Groundwater Application Review Summary Form

Application # G- 19361

GW Reviewer Phillip I. Marcy Date Review Completed: 05/08/2026

SUBJECT: Scenic Waterway Interference Evaluation

Water-Level Measurements in Nearby Wells

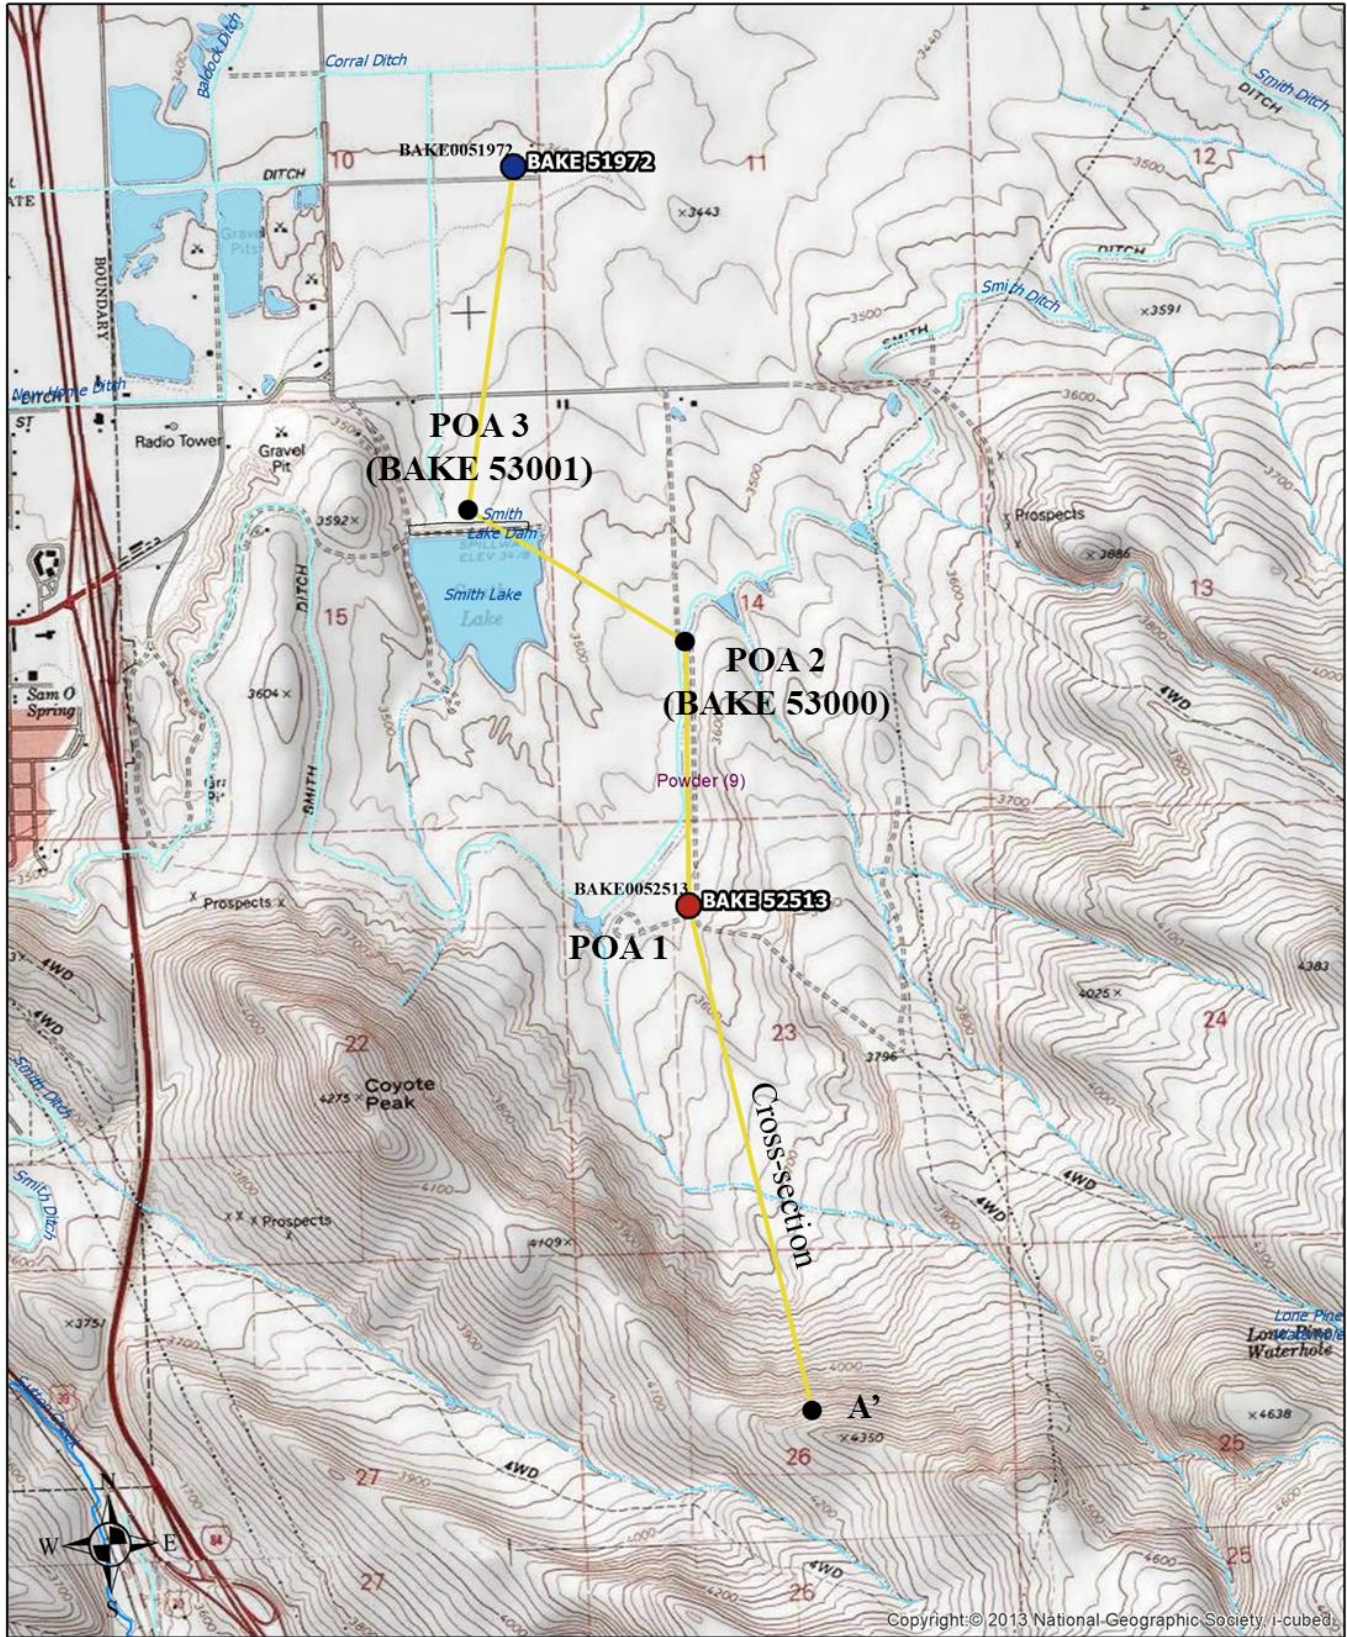
At the time of re-review, all three POA wells have been constructed and brought online. Resulting water level data do not indicate that the proposed aquifer is over-appropriated at this point (see attached hydrograph).

POA wells authorized under G-17563 and proposed on this application do not display declines that suggest over-appropriation of the productive aquifer.

Cross-Section

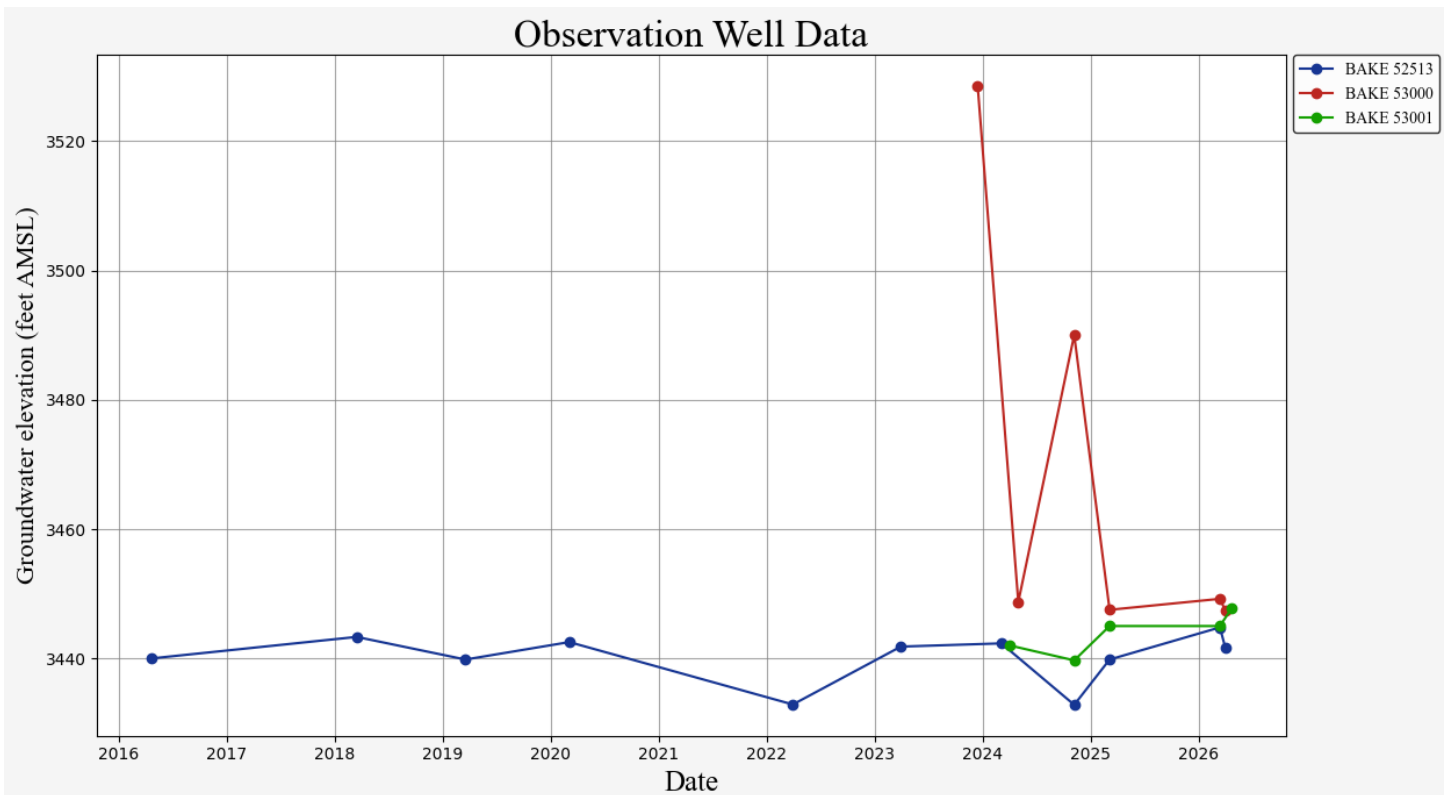
Basis for aquifer confinement evaluation: Static water levels of wells completed within the local basalt aquifer system are significantly higher than the water-bearing zones at which water was encountered. Two 740 foot deep wells in this section, located within 500 feet of the proposed location for “Well 3” on this application, encounter basalt at 700 feet. Stated water levels at these wells are less than 20 feet below land surface, and stated yields are 1500 GPM (BAKE 1080) and 2200 GPM (BAKE 1079). According to Trauger (1951), these wells produce water from Tertiary volcanic and sedimentary rocks on the northward dipping limb of an anticline. Completion of POA Well 1 (BAKE 52513) has provided further evidence toward high yielding wells, in addition to high degrees of confinement within the target aquifer for Wells 2 and 3.

Basis for aquifer hydraulic connection evaluation: The volcanic aquifer here appears to be buried beneath about 700 feet of alluvium, and connection to surface waters is likely tortuous and inefficient. Little information is available concerning the physical properties of the volcanic aquifer system, but assuming the character is similar to regional basalt aquifers of the Columbia Plateau, groundwater would migrate much more quickly horizontally than vertically, dispersing impacts to surface water out beyond one mile.
